Item No. 15 Town of Atherton

CITY COUNCIL STAFF REPORT – PUBLIC HEARING

SUBJECT: APPEAL OF A PLANNING COMMISSION DECISION TO DENY A HERITAGE TREE REMOVAL (HTR) PERMIT AT 1 ELM PLACE

Figure 1: Location of Trees Proposed for Removal & TPZ Exception

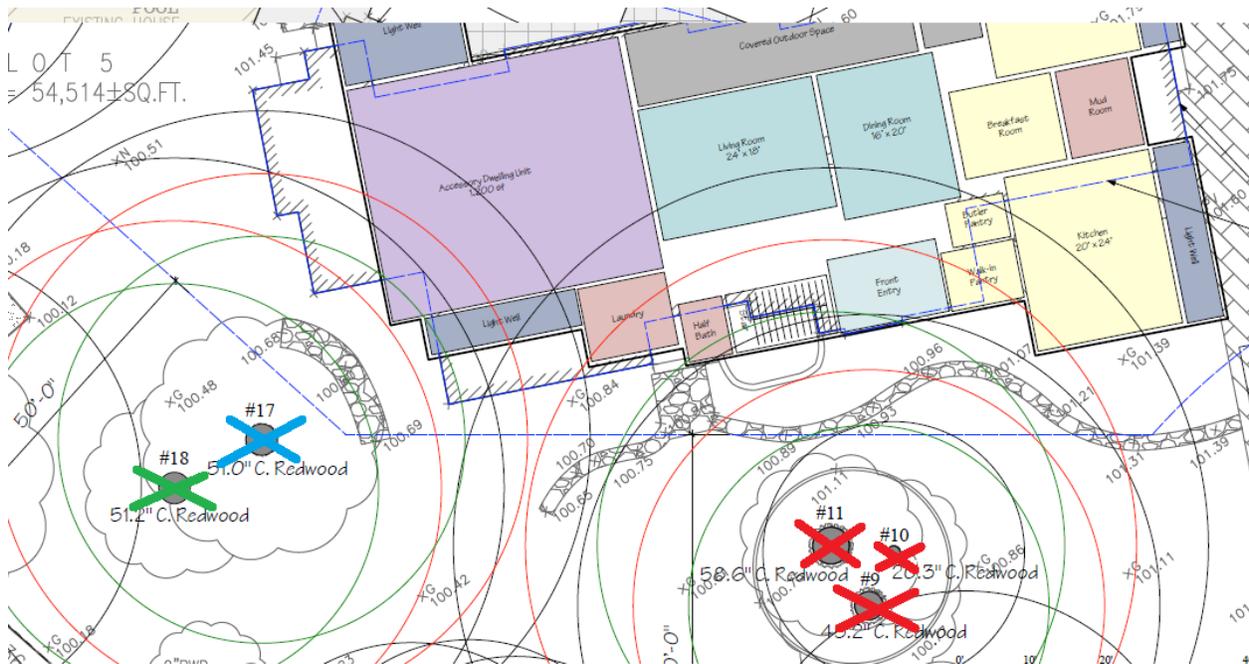
The property owner also requested the removal of three (3) additional heritage redwood trees (Trees #9, #10 and #11, marked with a red X's in Figure 1 below), to accommodate the future proposed new main residence. Such request was denied by the Town Arborist and referred to the Planning Commission. The blue line in Figure 1 below outlines the footprint of the existing home with the colored squares outlined in black, indicating the location of the proposed new main residence.

The three (3) heritage redwood trees proposed for removal could be preserved with modifications to the project design to locate the main building further away from the trees or construct a residence at a modified location from that currently proposed accompanied by a TPZ exception for both the proposed main house and its basement. Preservation of the three (3) heritage redwood trees, would reduce the amount of allowable development to be less than the maximum allowable as established zoning parameters may otherwise consider. However, while preservation of these three (3) heritage trees would not allow the property to develop to its maximum extent feasible, development is not entirely precluded as there would still be the ability to construct improvements within the main buildable area.

Figure 2: Location of Tree #11 From Existing Main Residence – Prepared by Town Arborist

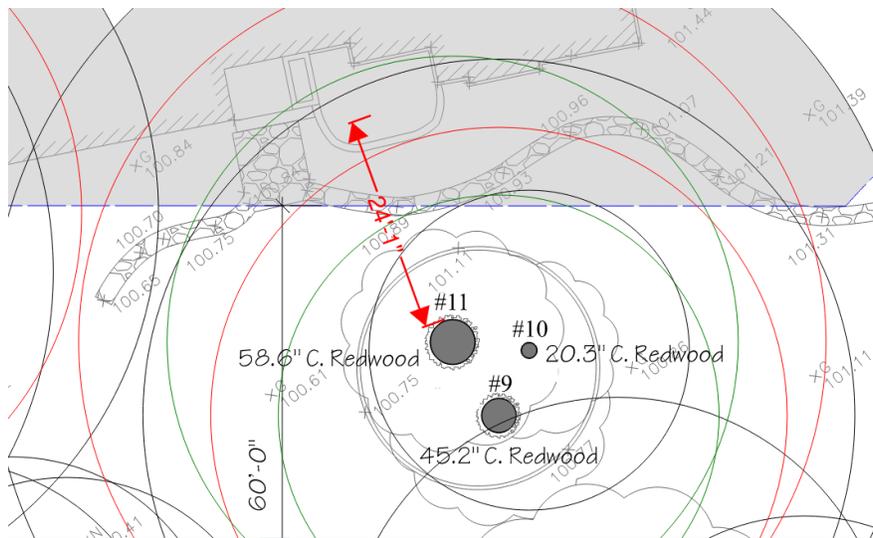
The Town Arborist has reviewed all appeal materials submitted that were not included as part of the Planning Commission application and has prepared a detailed supplemental assessment memo (Attachment 4). The Town Arborist's original assessment memo is included within Attachment 2. As discussed above, the Town Arborist would be able to support both the staff level TPZ

exception of 8x for the basement and an application to the Planning Commission for an exception of 6x for the first floor of the main residence. In terms of the timing of regulations from 2013 to date, the Town Arborist notes that the TPZ requirement in 2013 was at a 12x TPZ, with any request for reductions assessed on a case by case basis. Based on prior exceptions granted, the Town Arborist notes that no TPZ exception of any less than 6x TPZ had been granted as it would encroach into a trees critical root zone. It is noted that while branches of the tree(s) would be pruned upwards, it is not recommended to over prune a redwood tree. The Town Arborist notes that the largest of the trees most closely located to the main residence (Tree #11) is situated approximately 24 feet from the existing main residence as indicated in Figure 2 below.

Figure 3: Existing Structures and Trees with TPZs– Prepared by Applicant

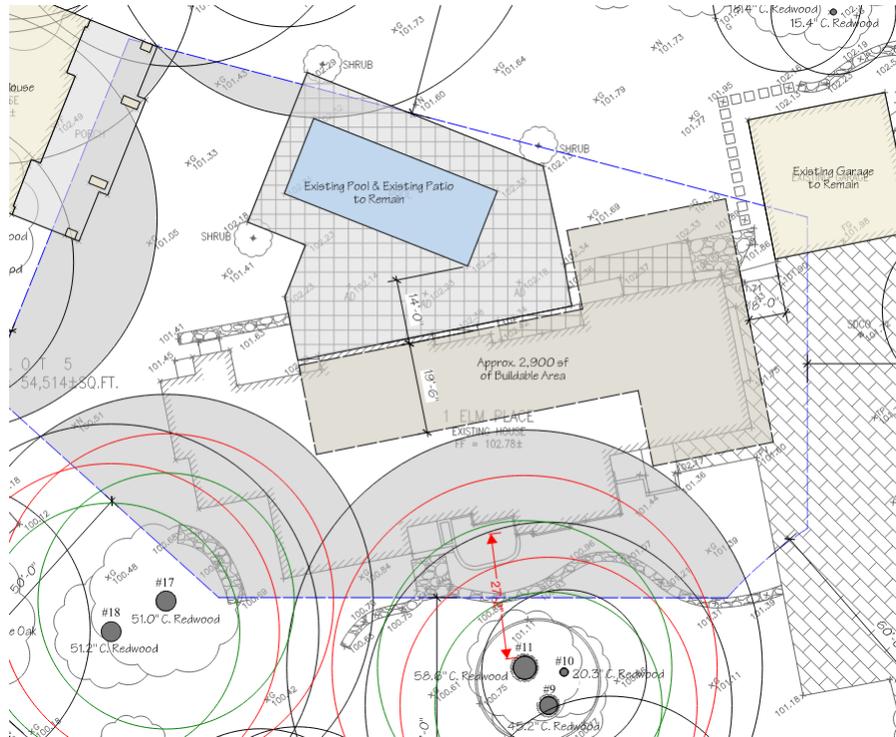
The applicant's provided the following Figure 3 to illustrate existing conditions and trees within the defined main buildable area (outlined in blue), in which their plans note approximately 2,900 square feet of buildable area after accounting for TPZs. However, the Town Arborist notes that this calculation is shown utilizing a 10x TPZ, and such square footage number would increase if calculated at either an 8x or 6x TPZ (i.e. reduced TPZ distances if a TPZ exception request was pursued) and additionally does not account for the existing patio area and swimming pool. The Town Arborist also notes additional on-site trees noted to be in fair to poor condition that if evaluated for removal, may be considered in a revised main residence building approach. The Town Arborist notes that redwood trees are fire resistant, that under existing conditions the trees are not found to be a fire hazard, and that the Town does not have any defined Wildland Urban Interface (WUI) zones, so defensible space is not required.

It is the professional opinion of the Town Arborist that the trees do not pose a safety concern and/or hazard, and that there are alternative development approaches available that would preserve the three (3) trees in question, and not compromise the protection of other on-site heritage trees to remain to allow reasonable use of the property.

Diagram 1

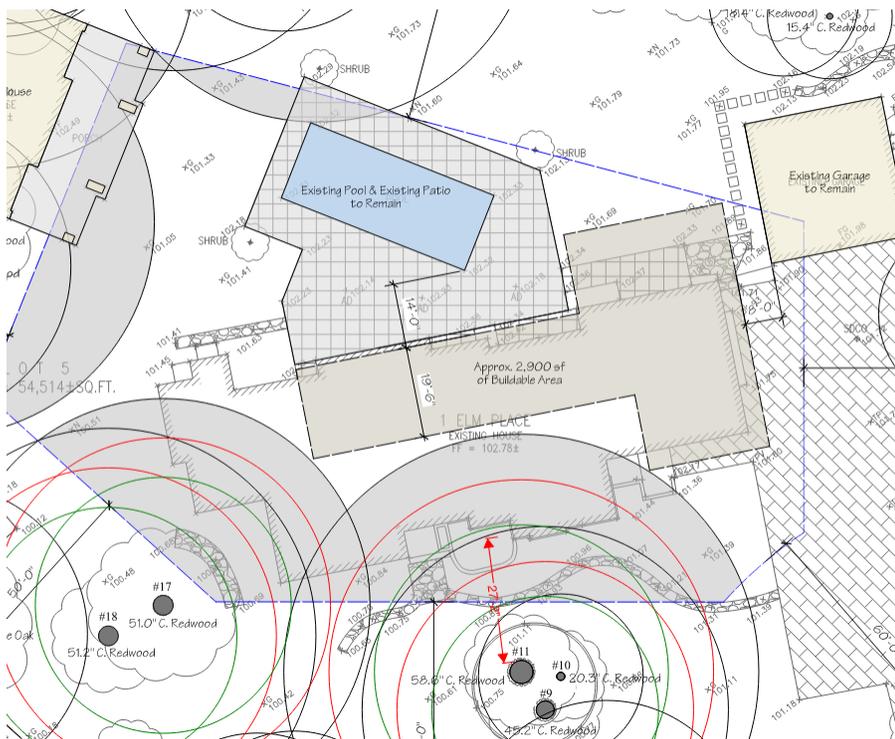
I also wanted to point out in Figure 2 of the plans submitted that they show that there is only 2,900 square feet of buildable area to build. However, this is shown at 10x away. A more accurate depiction would be at 8x and 6x accordingly to my recommendation if they applied at Planning Commission level. That would allow for more square footage. I also wanted to point out that in the applicants 2,900 square footage calculation that they calculated keeping the pool and large patio area surrounding it.

The applicant wishes to keep the pool and patio area which takes up a large amount of buildable area space for building a new residence. You will see in diagram 1 the 2,900 sf of buildable area, but it doesn't consider the pool area and patio area. If it did the square foote to build a new home would be much larger.

Diagram 2

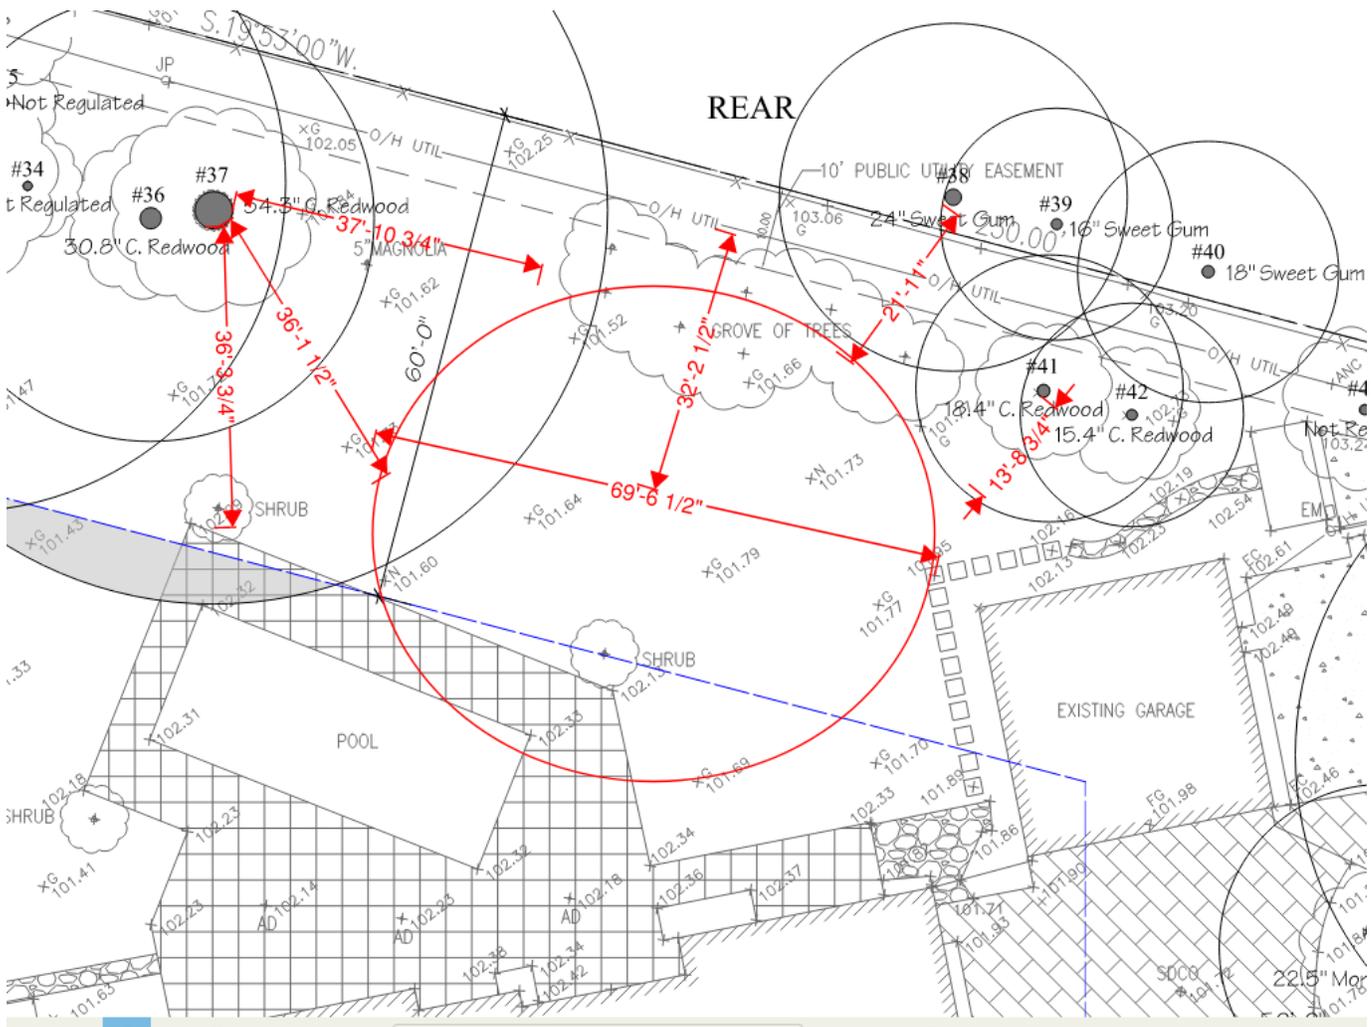
I also wanted to show in diagram 2 below that there may be space for a pool/patio in the back yard. I calculated the distances from the Redwood trees at 8x and the Sweetgum at 10x. I also calculated the overhead wires away as well as the approximate distance across to be at 69'. A lap pool is approximately 40' long. I feel not being able to move the pool, that, that is a factor in not being able to use the lot to the extent feasible. Many sites in Atherton have high voltage PG&E lines that go through the back yard property line. I do not know of a required setback from the lines to where you can build in the backyard. However residents with power lines are still able

to use their backyards.
